Point Beach Nuclear Plant, Units 1 and 2  
Dockets 50-266 and 50-301  
Renewed License Nos. DPR-24 and DPR-27

Response to Request for Information Supporting Flooding Hazards Reevaluation Report Audit

**RESPONSE TO REQUEST FOR INFORMATION SUPPORTING  
FLOODING HAZARDS REEVALUATION REPORT AUDIT**

Figure 4.5, PBNP Door Locations

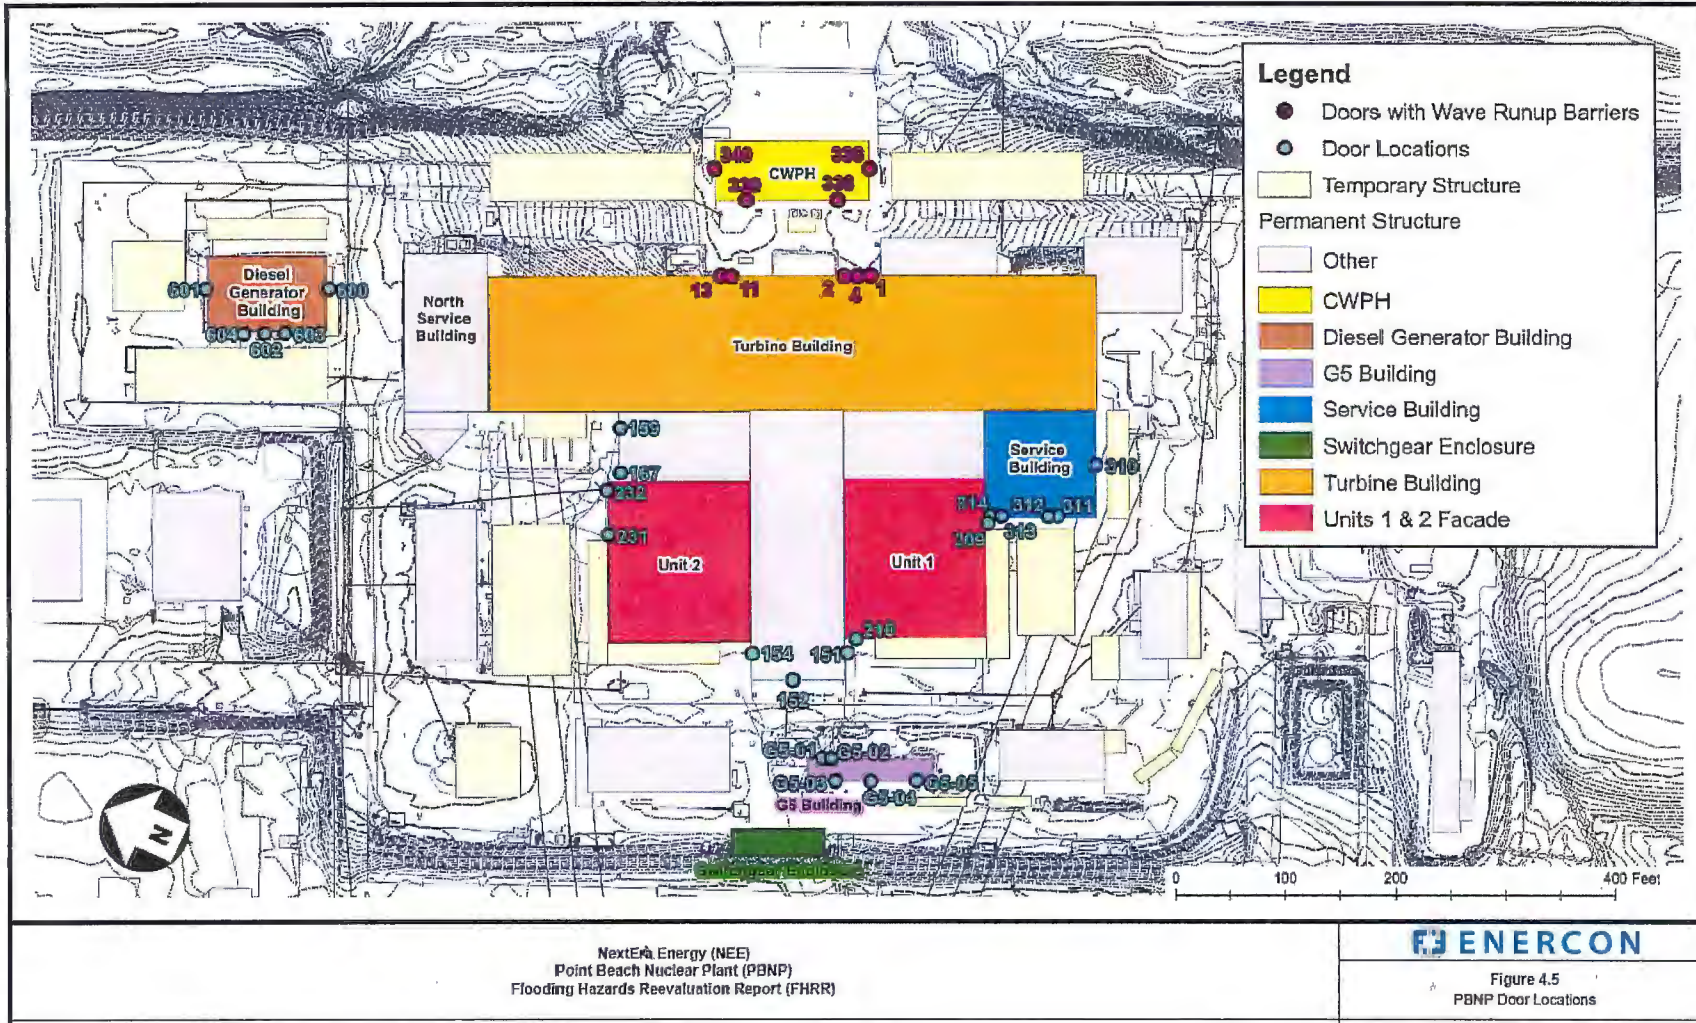
*Provide updated figures, where necessary, to accurately distinguish the locations and areal extents of temporary wave barriers. If possible, make door numbers more legible in FHRR Figure 4.5.*

FHRR, Figure 4.5, PBNP Door Locations, has been updated to improve the display of the door numbers. The updated figure is included in Enclosure 2.

Original Elevations East of the Turbine Hall

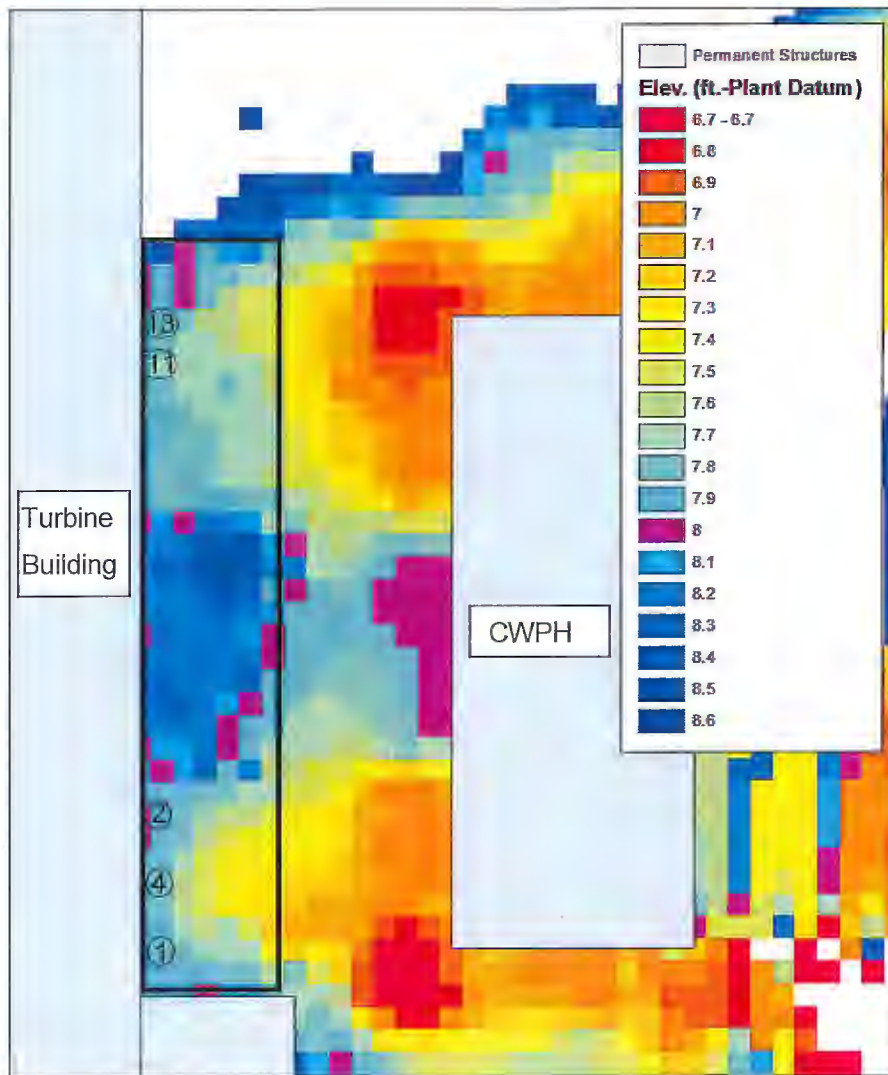
*The FHRR states that the elevations of the grid cells to the east of the Turbine Building were manually set at 589.3 ft NAVD88 (+8ft -Plant Datum) for reasons of accurately determining flood elevations and model stability. Provide more information on the modification of the Digital Terrain Model to 589.3 ft NAVD88 (+8 ft-Plant Datum). Specifically, what was the original elevation and why was that elevation revised for accuracy and model stability?*

A supplemental figure, titled "Original Elevations East of Turbine Hall" is provided in Enclosure 2. The figure shows the unaltered elevation data for the area east of the Turbine Building. The elevation cells within the black outline were manually set to +8 ft-Plant Datum (+589.3 ft-NAVD88). The ground elevations in that area range from approximately +7.0 ft-Plant Datum to +8.4 ft-Plant Datum. Based on the construction drawings of the Turbine Building, the floor at the east end of the building (where Doors 1, 2, 4, 11 and 13 are located) are at an elevation of +8 ft-Plant Datum. The model cells adjacent to these doors, interpolated from site survey data, were at elevations other than +8 ft-Plant Datum originally. To properly represent the door elevations, all the cells within the black outline were manually adjusted to +8 ft-Plant Datum. Although the manual alteration of grid cell elevations changes the surface topography, it does so in a conservative manner. In most of the area, storage capacity was removed by increasing the cell elevation to +8 ft-Plant Datum, which would slightly increase the maximum Local Intense Precipitation water surface elevations.
